ECE/TRANS/WP.29/2010/33
18 December 2009

Proposal for the 01 series of amendments to Regulation No. 112
(Headlamps emitting an asymmetrical passing beam)

Submitted by the Working Party on Lighting and Light-Signalling */

Figure A: Spherical Coordinate Measuring System

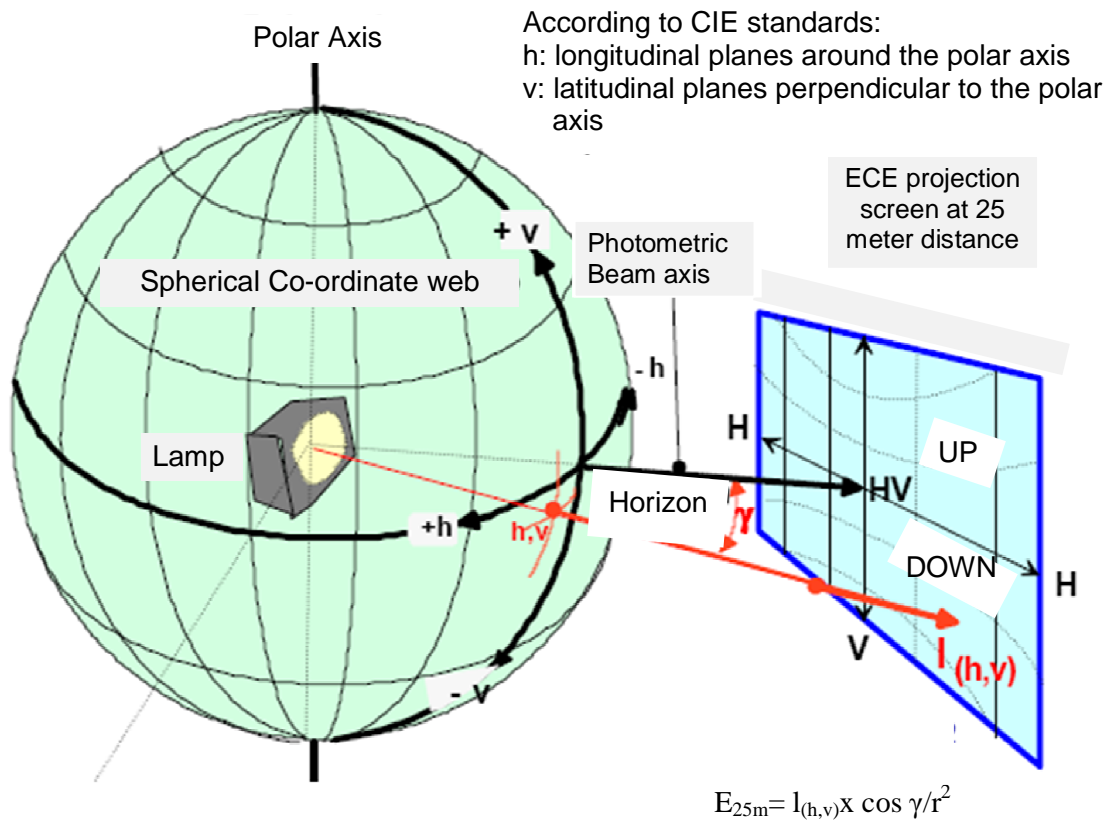
Annex 3, amend to read:

SPHERICAL COORDINATE MEASURING SYSTEM
AND TEST POINT LOCATIONS

Figure B: Passing Beam for right-hand traffic

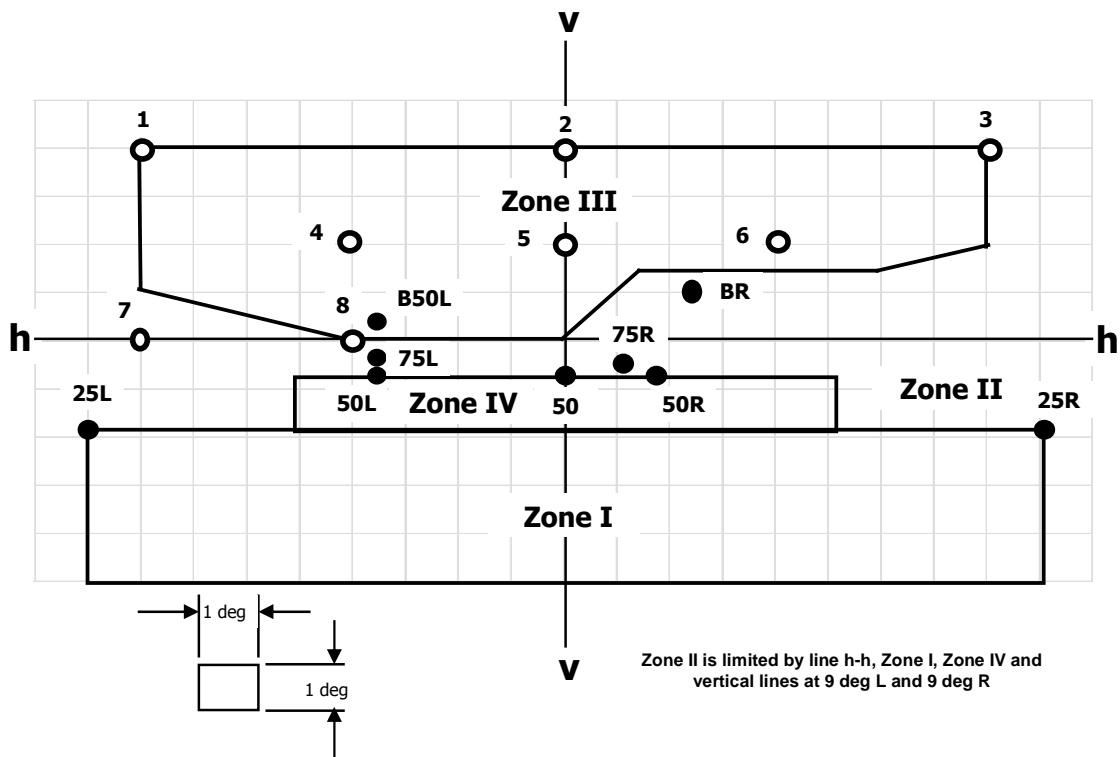
"6.2.4. The passing beam shall meet the luminous intensities at the test points referred to in the tables below and in Annex 3 figure B (or mirrored about the VV line for left-hand traffic):

The test point locations for left-hand traffic are mirrored about the VV line

Figure C: Driving Beam

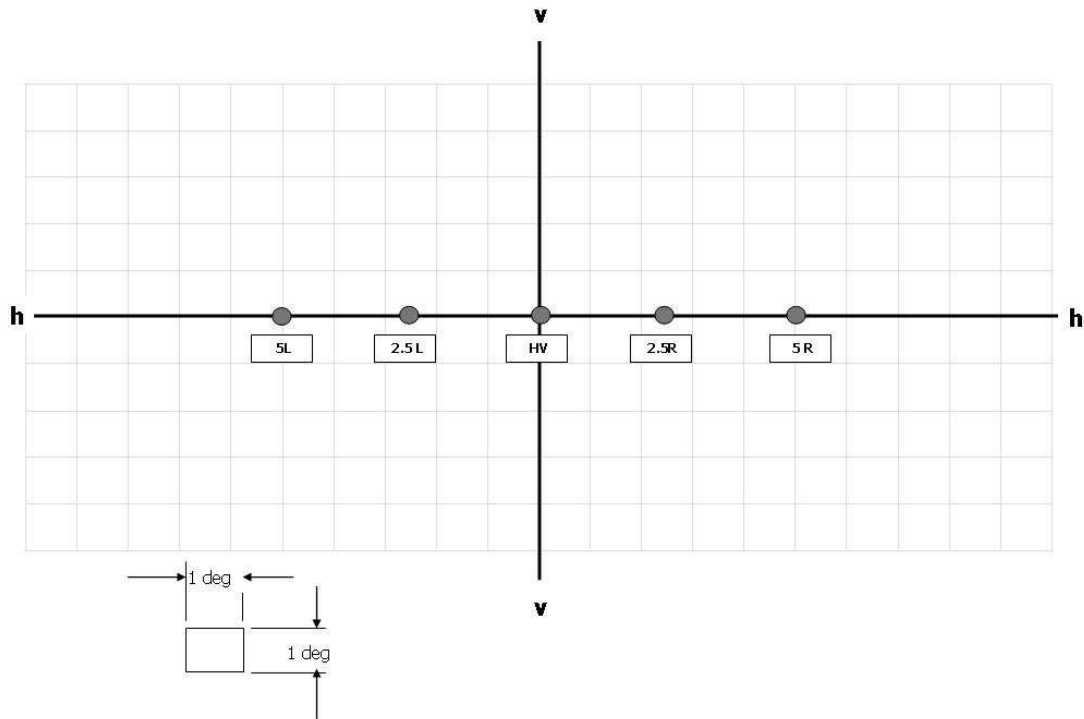
"6.3.3. Referring to Annex 3 Figure C and the table below, the luminous intensity distribution of the driving beam shall meet the following requirements:
